**IOWA DEPARTMENT OF TRANSPORTATION**

**TO OFFICE:** District 4  
**ATTENTION:** Wes Mayberry  
**FROM:** Alfred Benesch & Company  
**OFFICE:** Design  
**SUBJECT:** Field Exam (D-2)

**DATE:** March 16, 2018  
**REF.:** Pottawattamie County  
IMX-029-4(112)72--02-78  
BRFIMX-029-4(113)72--14-78  
PIN: 16-78-029-070

A field exam was held on Thursday, February 1, 2018, to review the proposed plan for the bridge replacement at County Road G12 over I-29 in Pottawattamie County.

**STAGE 1**  
**STAGING PLAN**

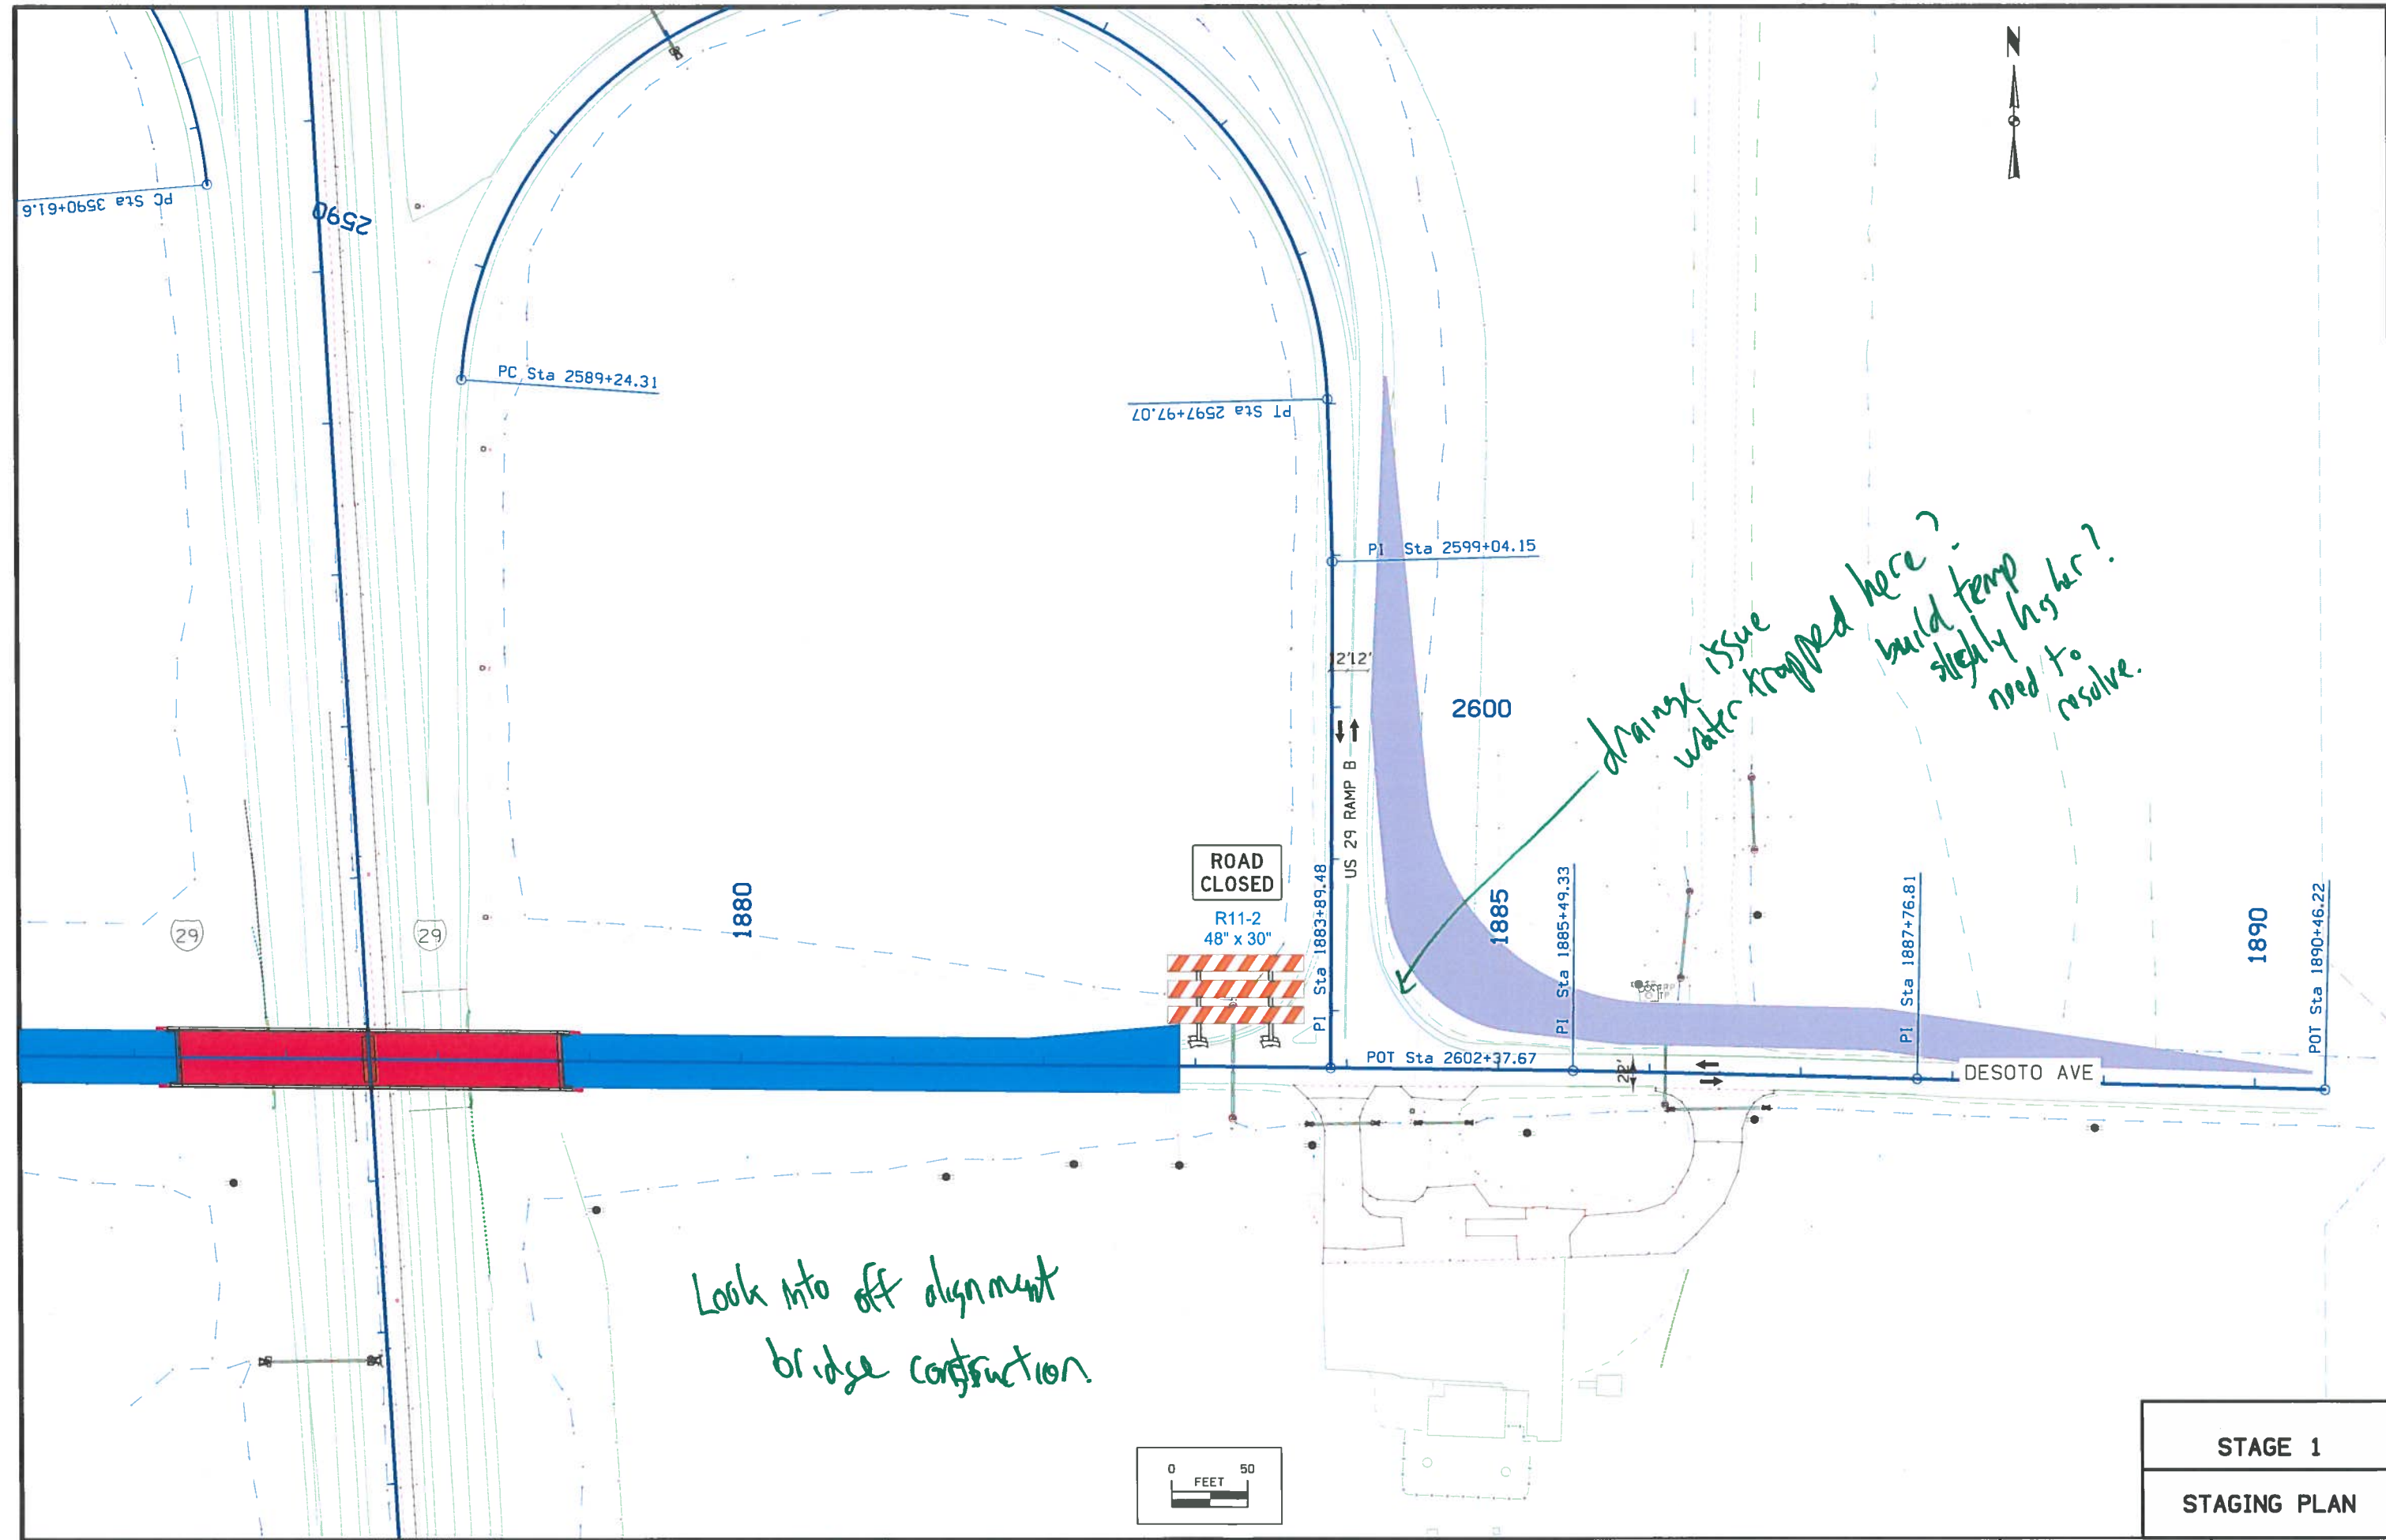
*drainage issue  
water trapped here?  
build temp  
slightly higher?  
need to  
resolve.*

*Look into off alignment  
bridge construction.*

US 29 RAMP B  
PLAN AND PROFILE

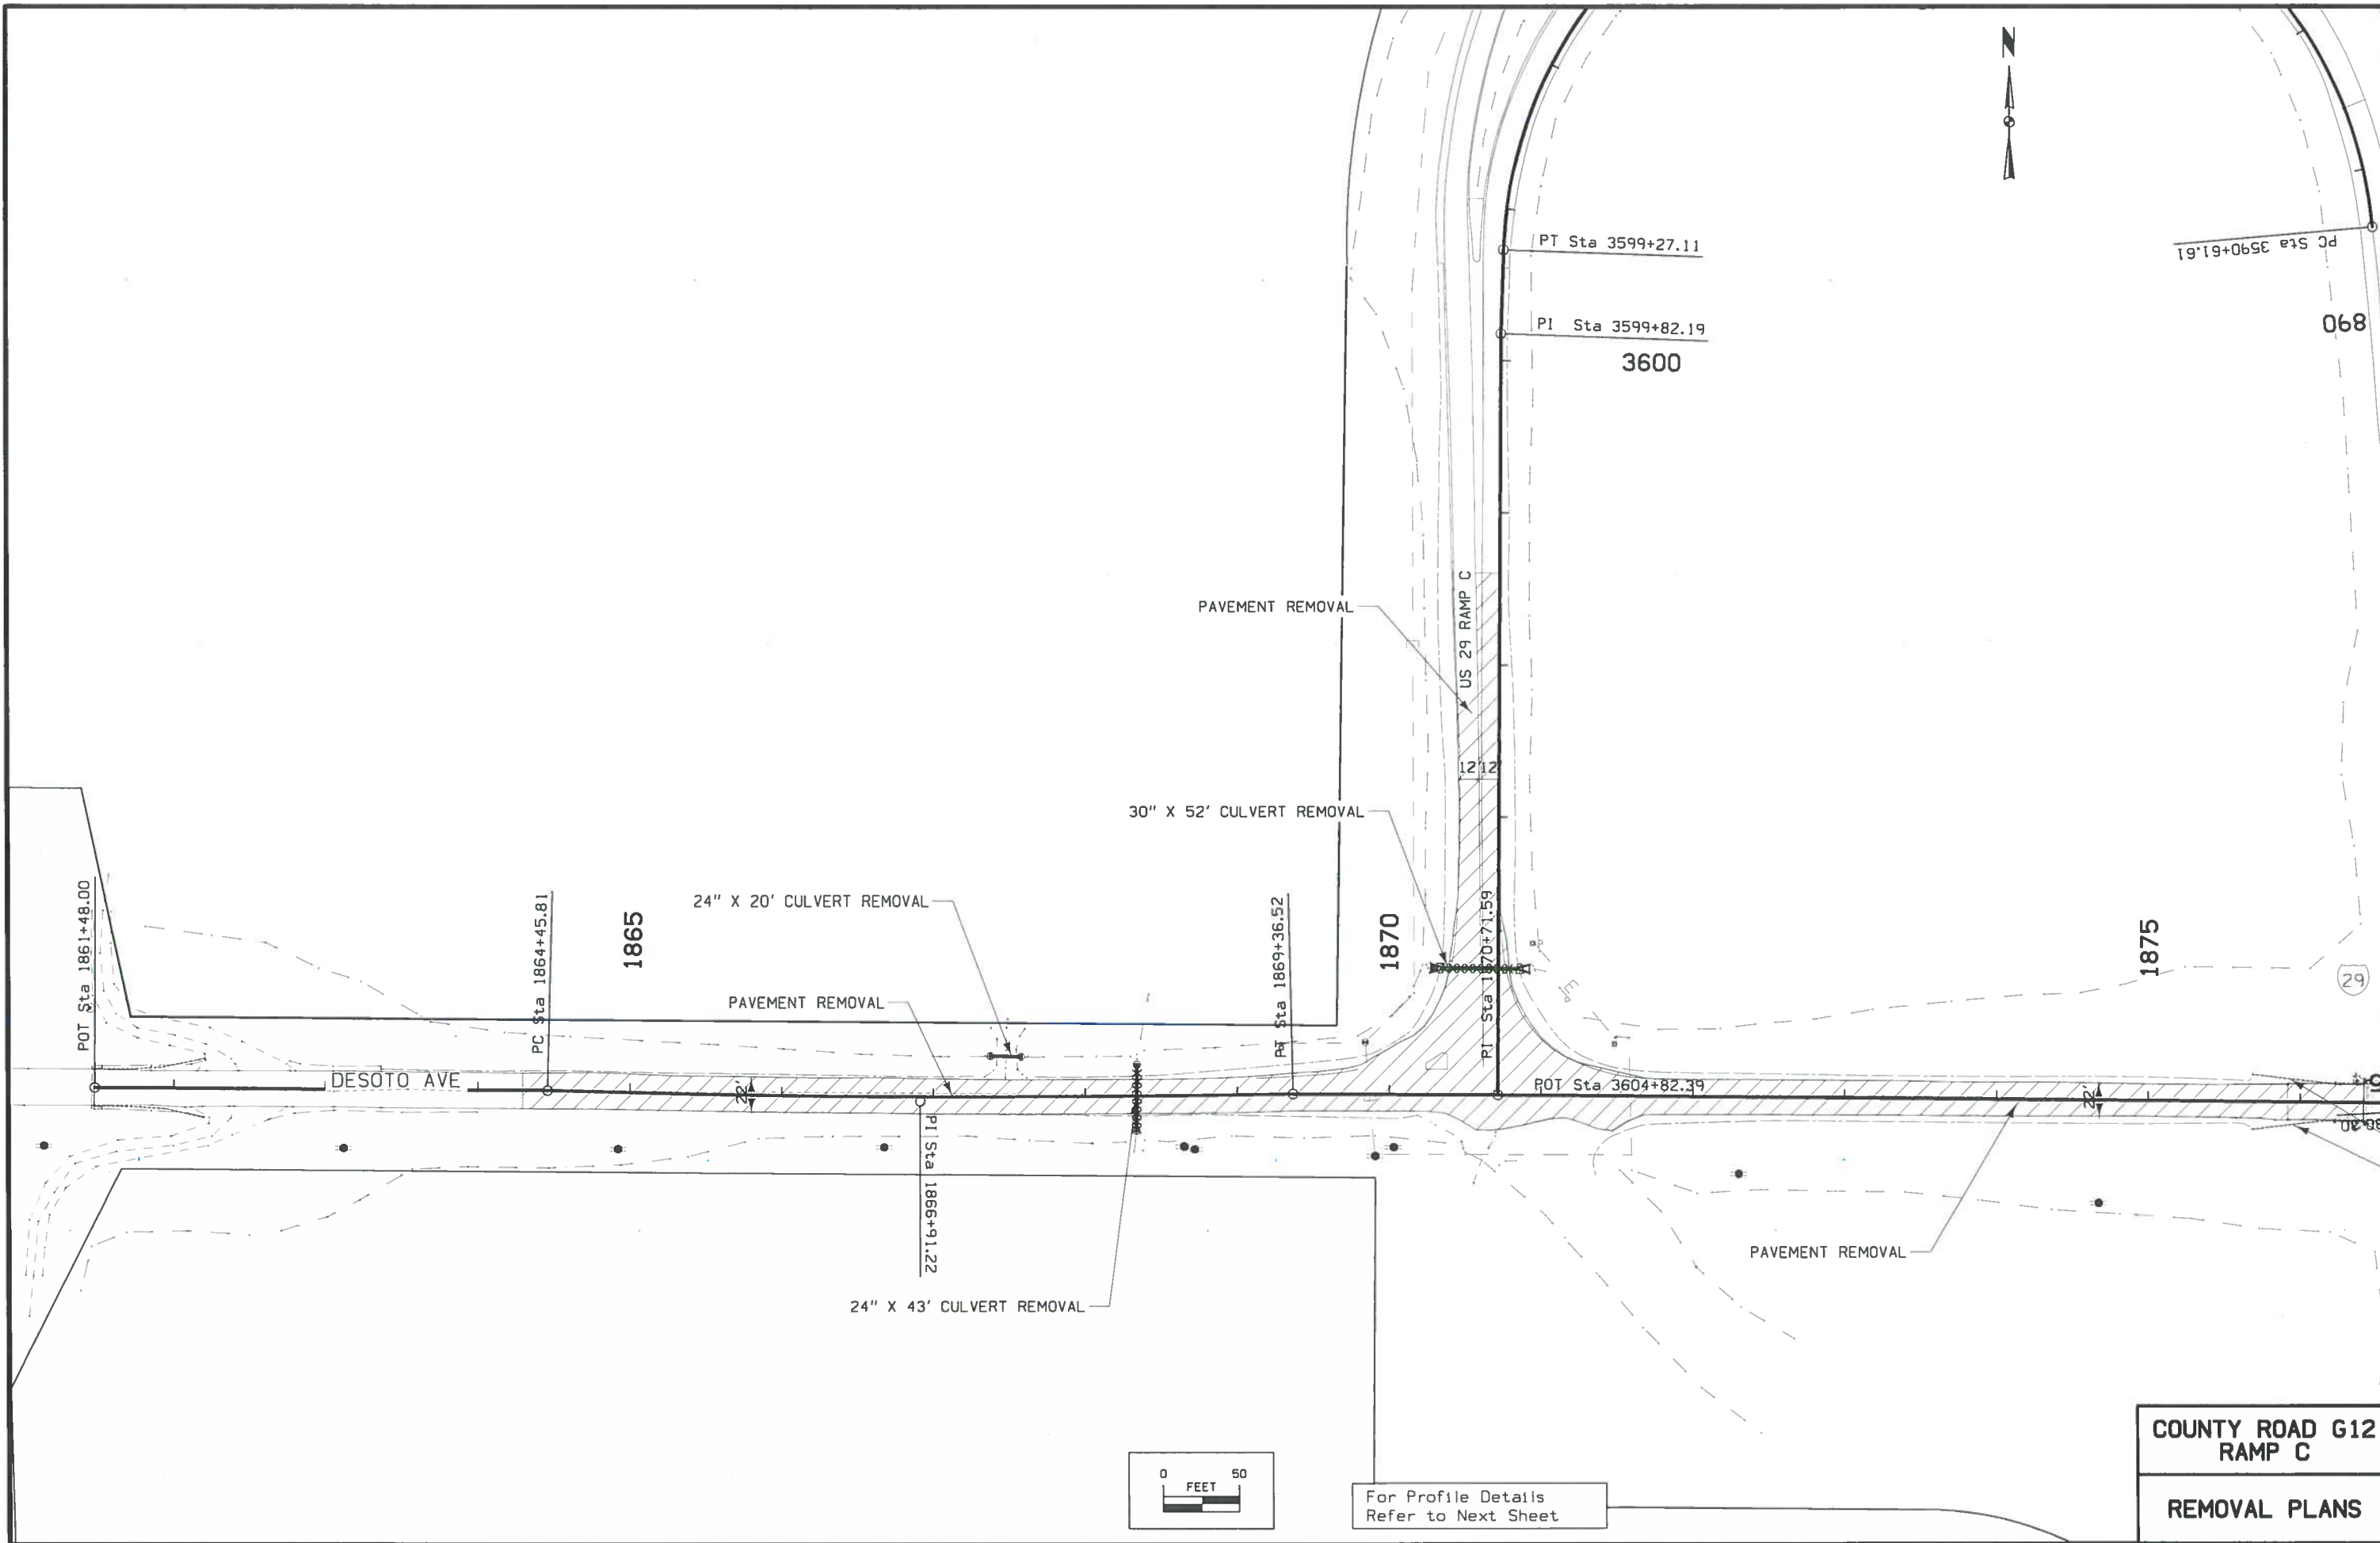
Same comments as D sheets.  
Move 2.00% label over the profile.
